## **Staff Report**

Re: PLNPCM2020-00015 Design Review

## **Design Review**

## Crossing at 9<sup>th</sup> Planning Design Review Submittal

#### A0.1 **ARCHITECTURAL SITE** PLAN **CROSSING AT 9TH**

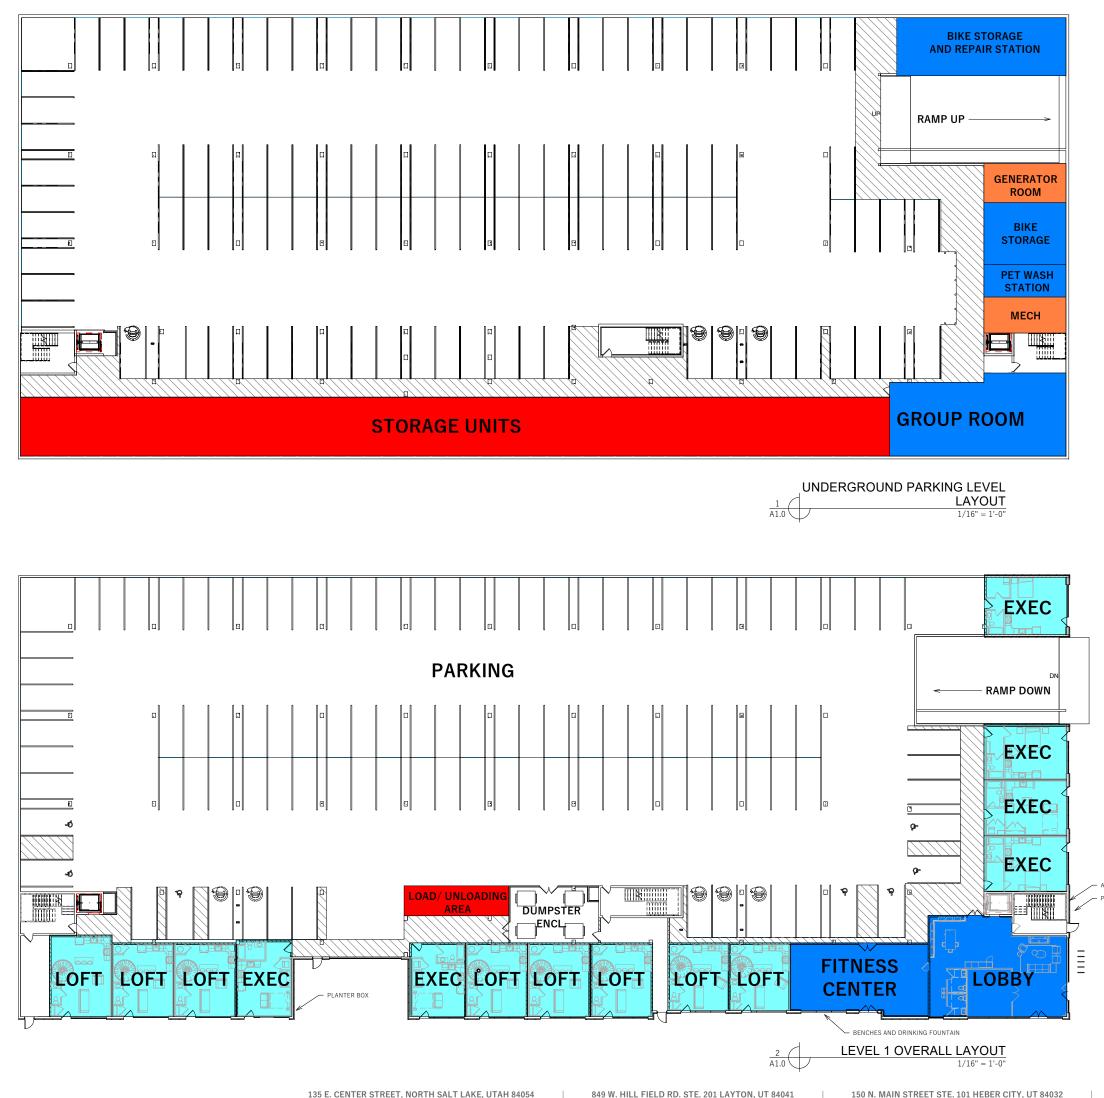
2. Provide a more detailed and dimensioned site plan showing all setbacks including from balconies, awnings, and canopies to property lines. Submitted site plan does not call out dimensions and does not have legible property lines or setbacks.

-Site plan is being revised by the civil engineer to be more detailed and clearer.

<sup>5</sup> A2.1 WEST ELEVATION (OVERALL) 1/16" = 1'-0"

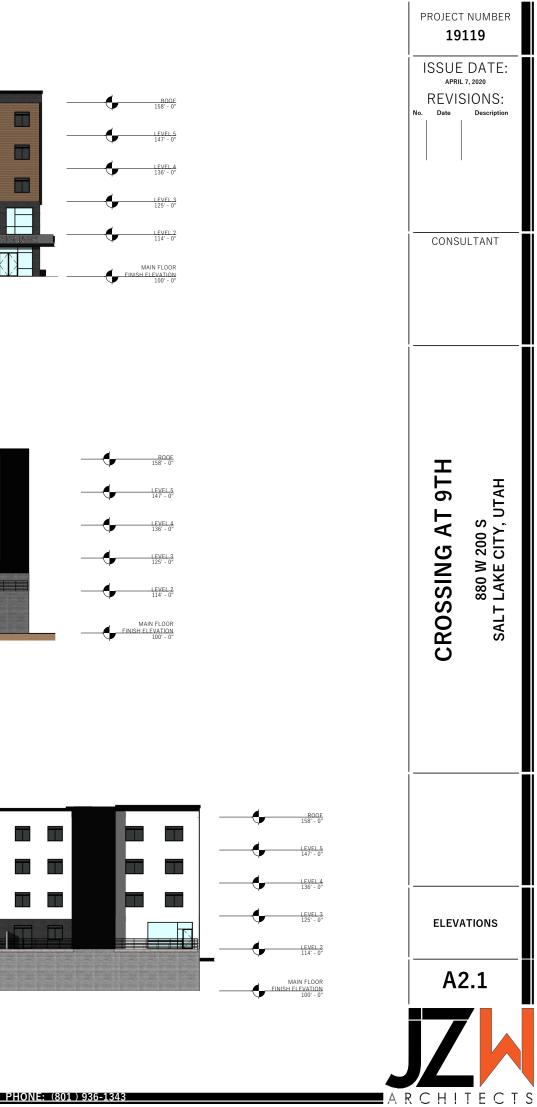
3. Building Entrances (21A.37.050.D): Building entrances along street facing facades are to be spaced no more than 40' apart in the TSA zone. The south end of the West elevation does not meet this standard. Please revise plans to meet this standard.

## -Two new building entrances have been added to fulfil this requirement. Please see A1.1 ENLARGED MAIN FLOOR PLAN and A2.2 NORTH & WEST ELEVATIONS.

LANDSCAPE PLAN PRELIMINARY PLANS NOT FOR CONSTRUCTION **LP-100**

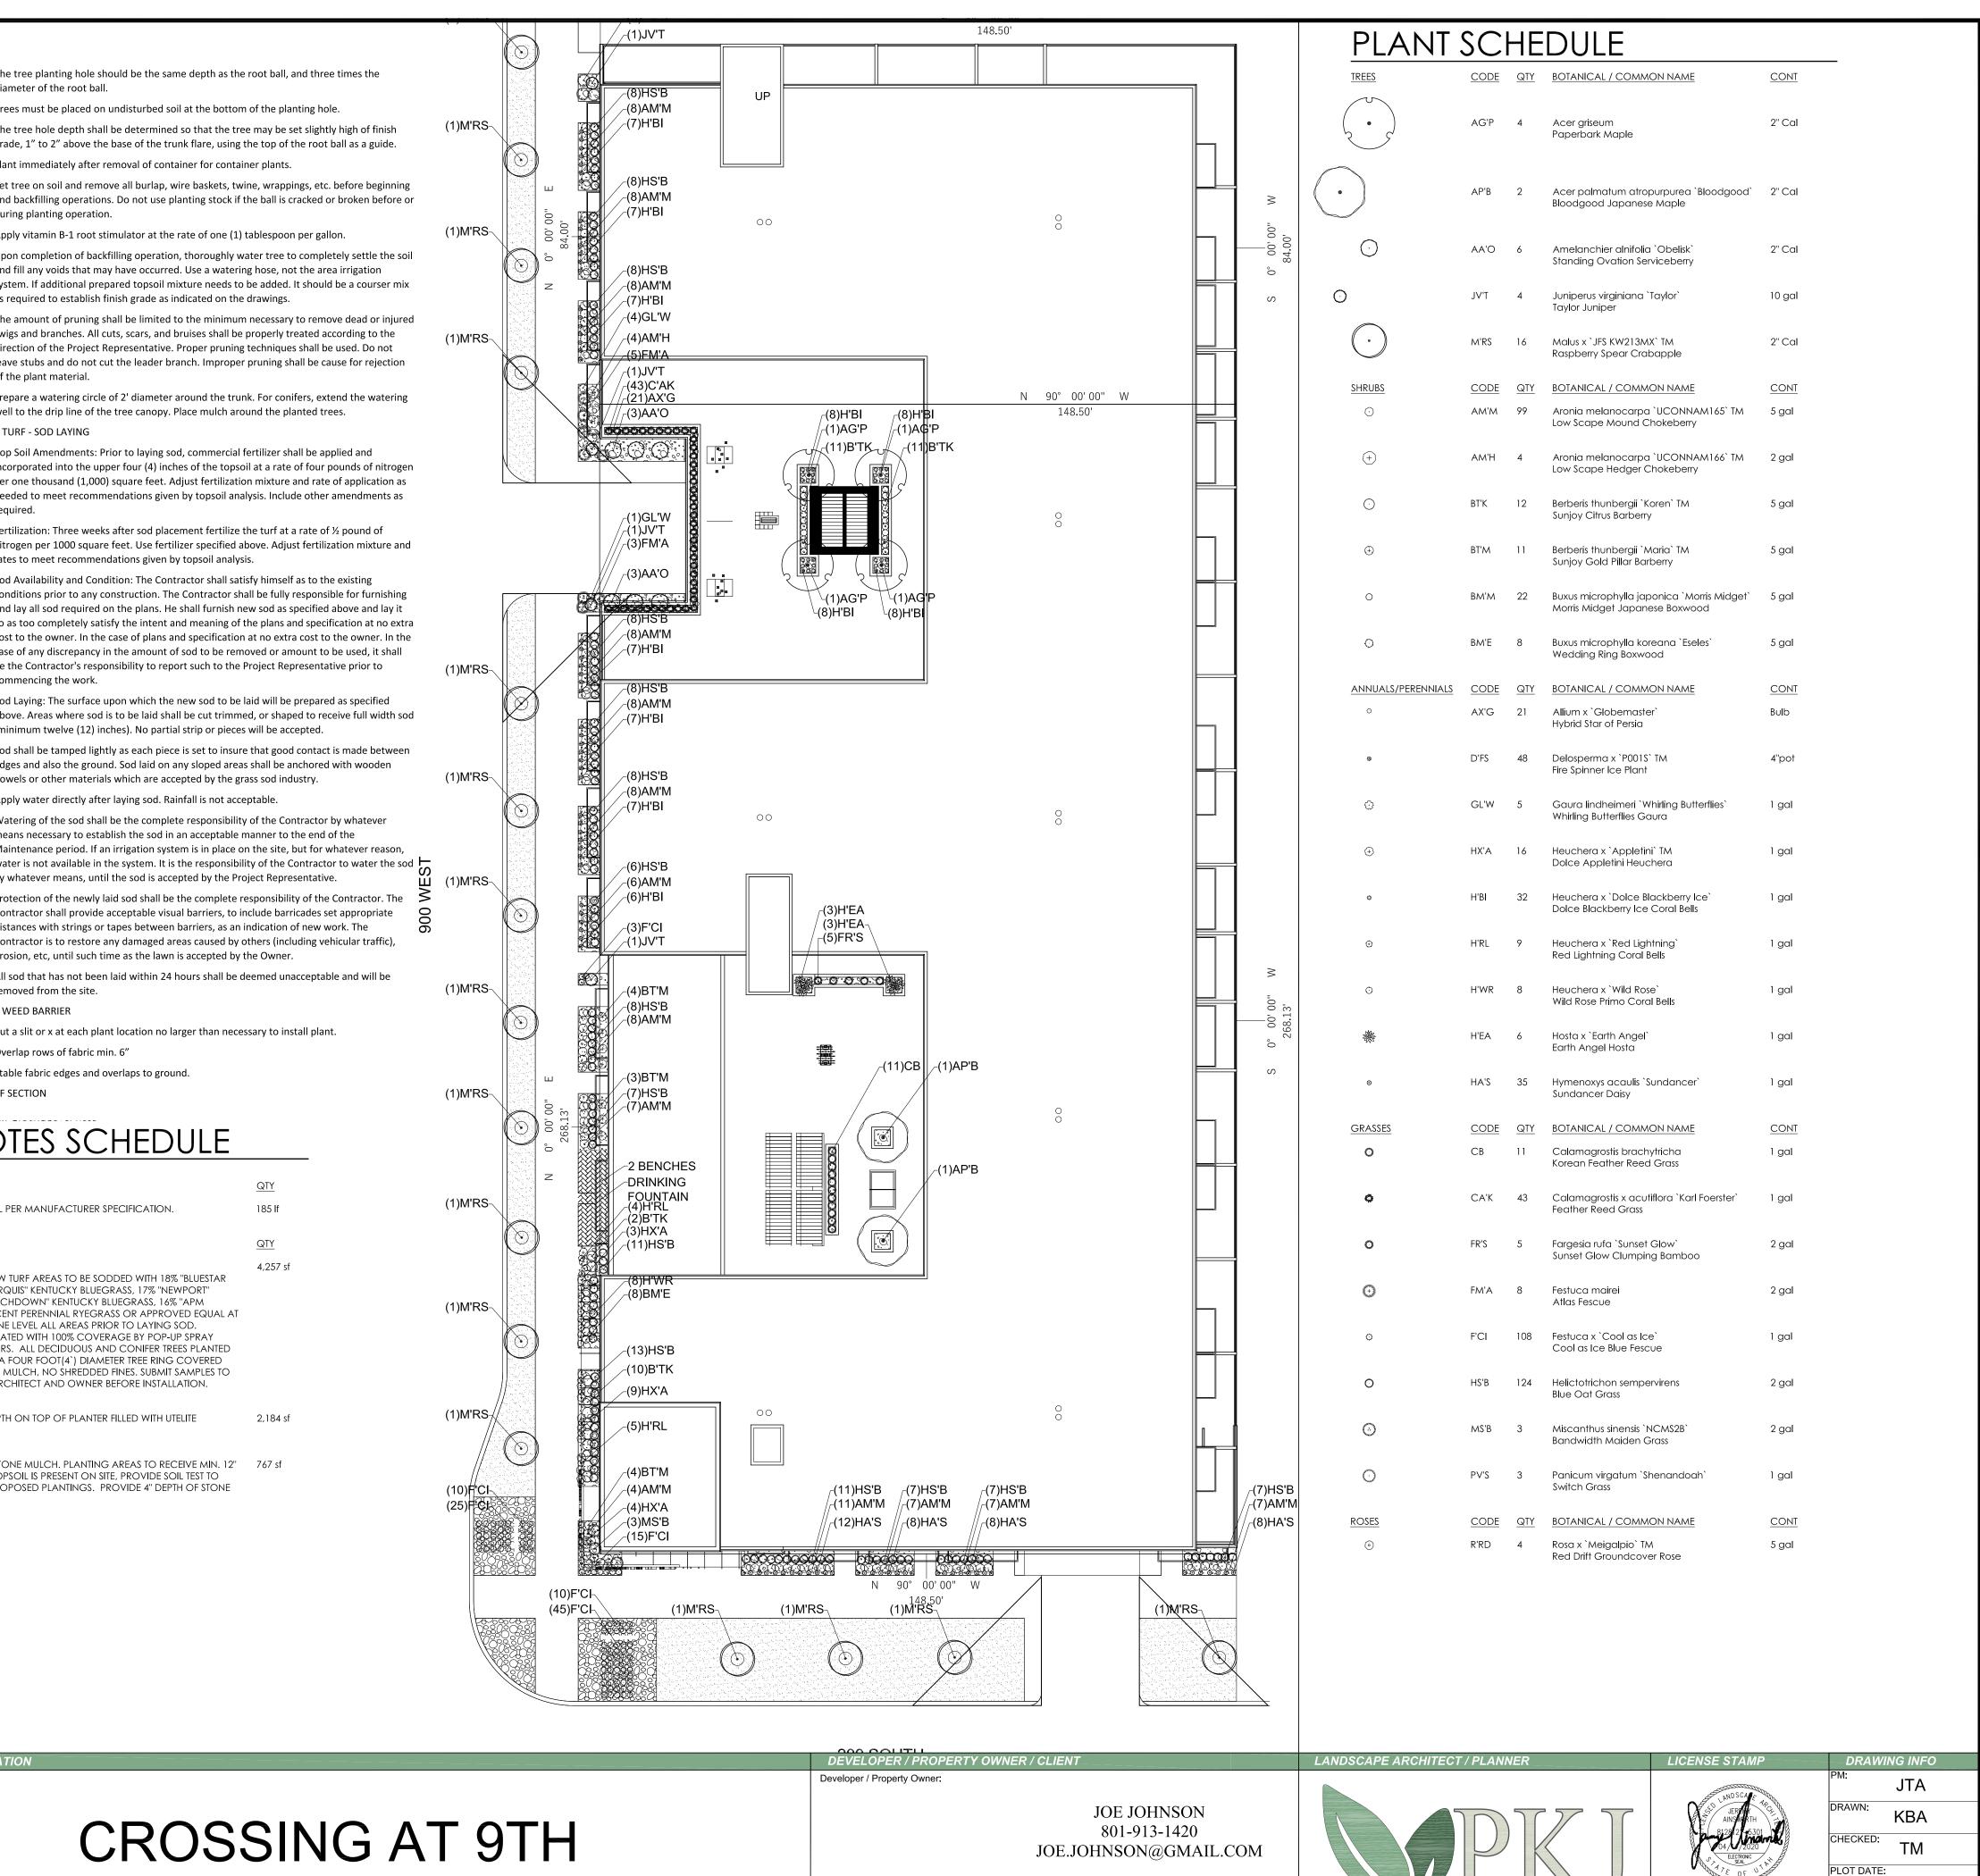
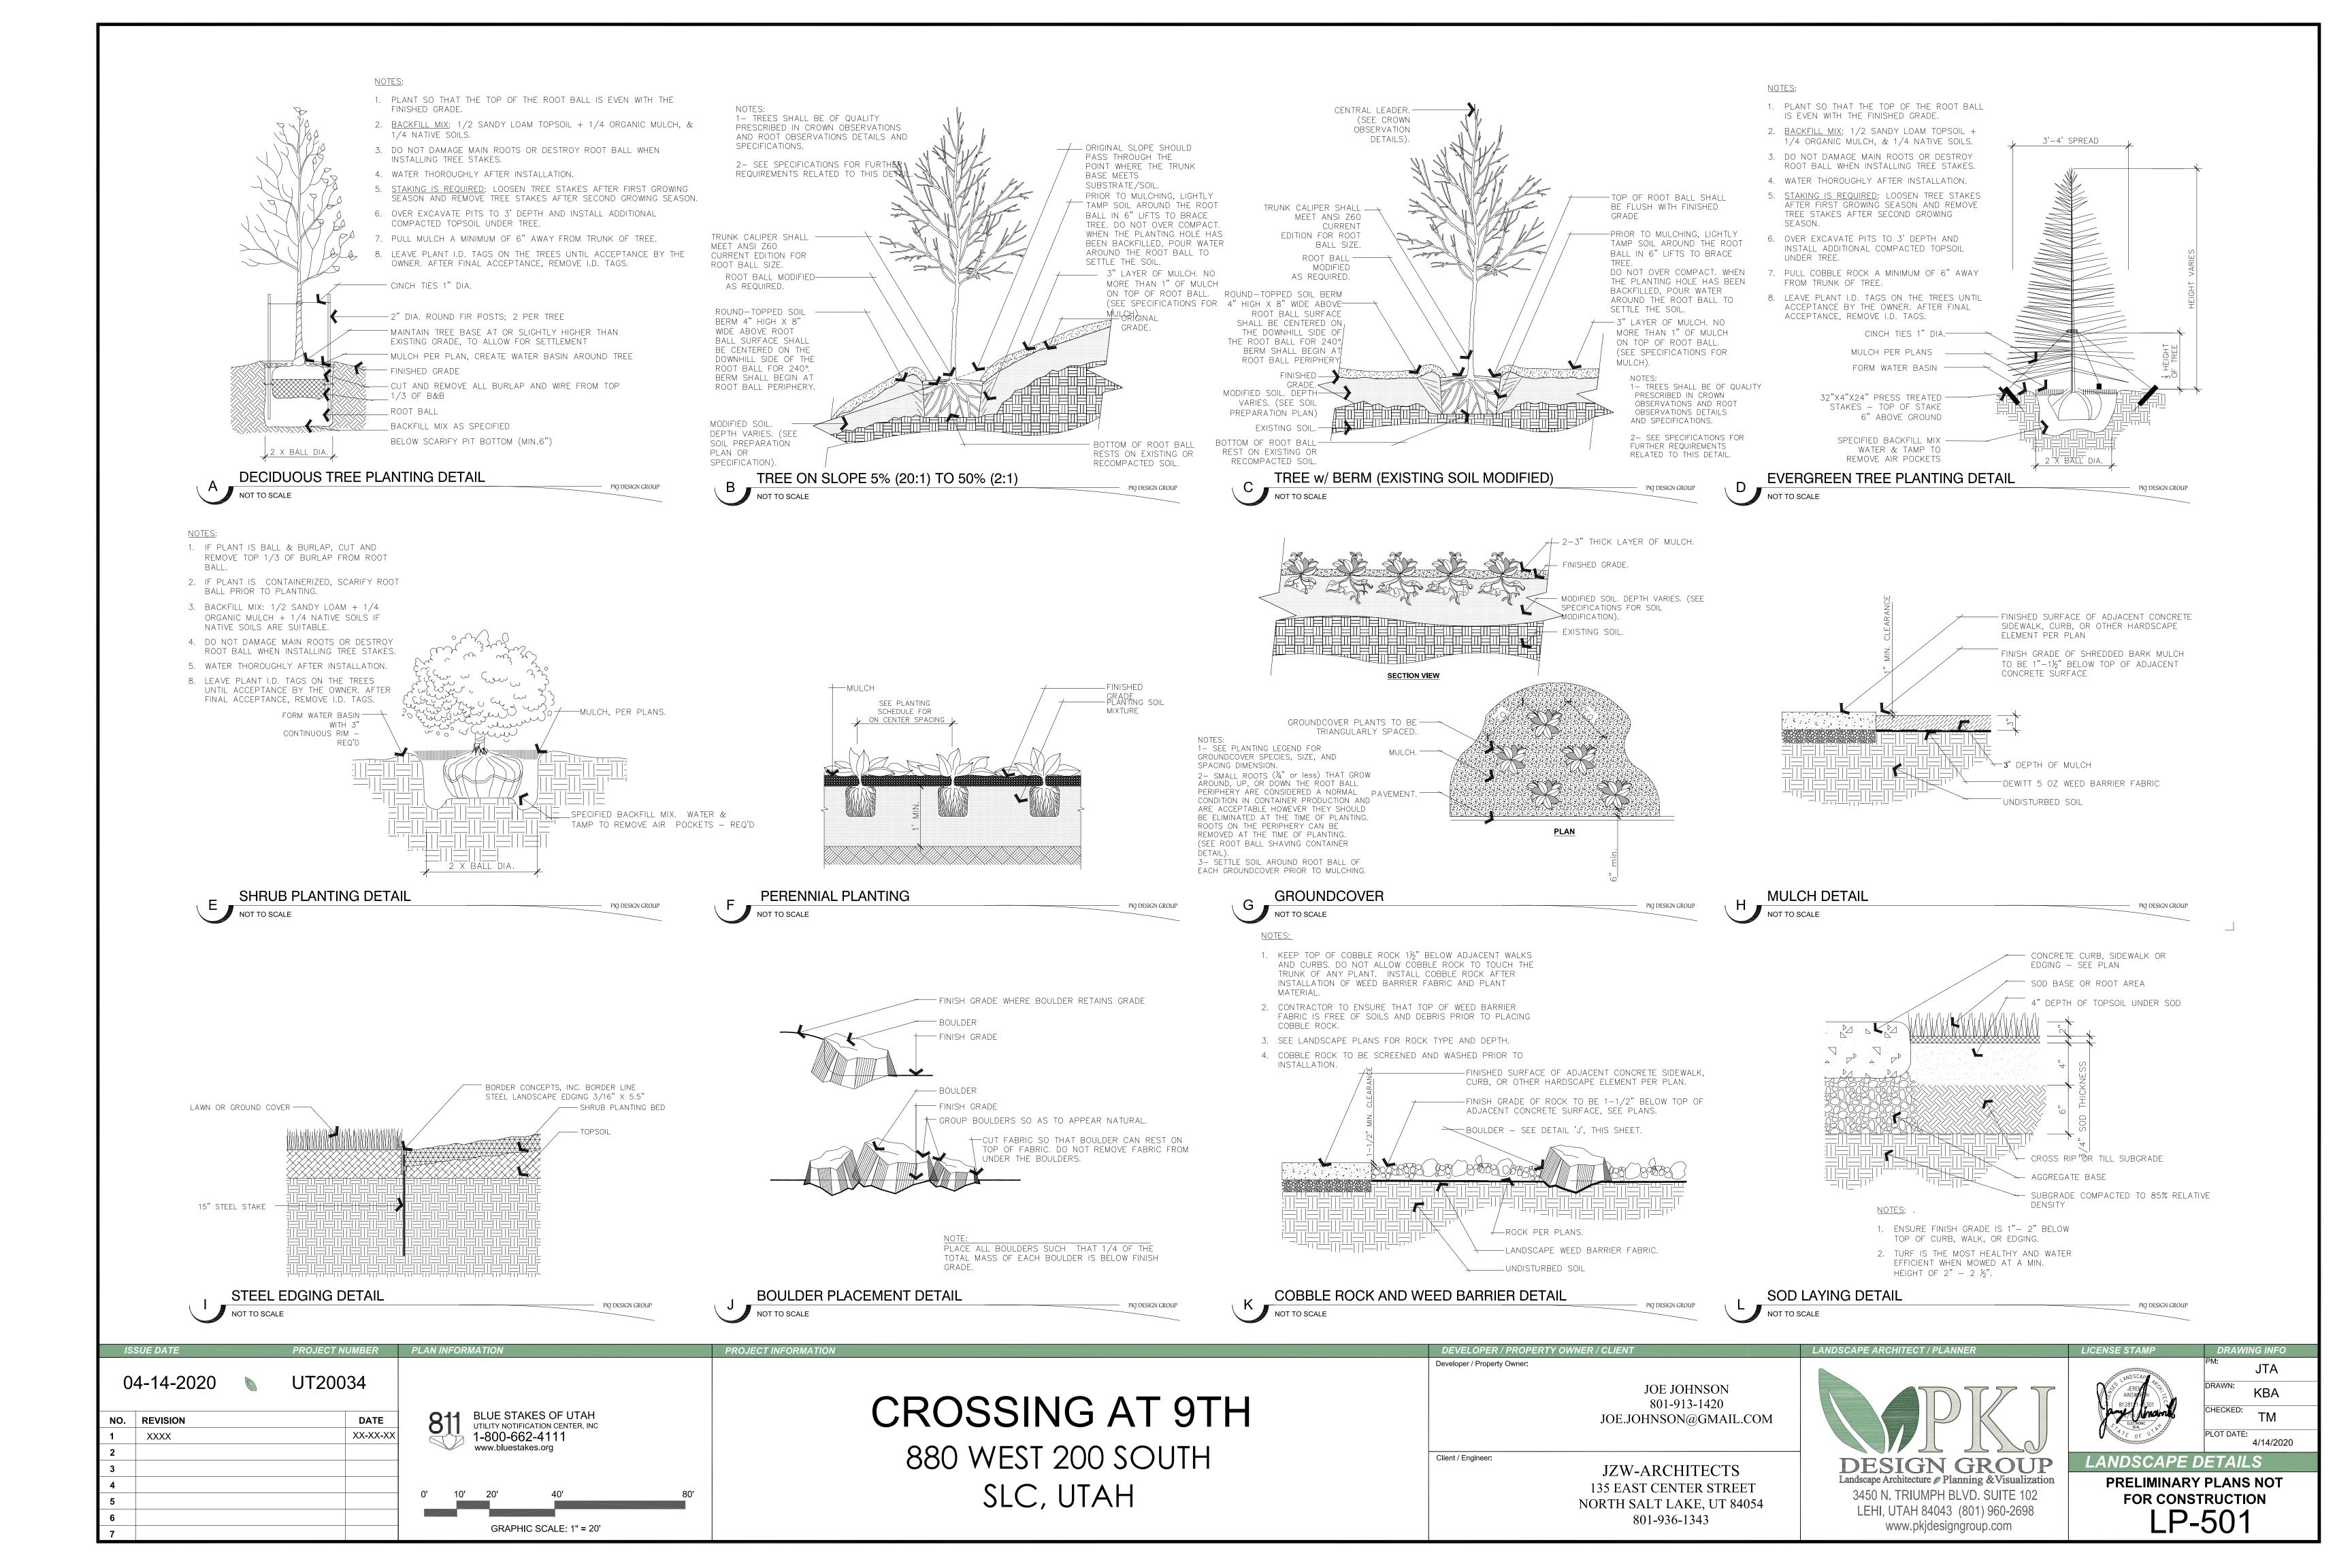
Please show this on landscape plans and provide explanation of compliance.

-The majority of the project does not include side yards and is built property line to property line. Landscape Architect is creating the Landscape Plan.
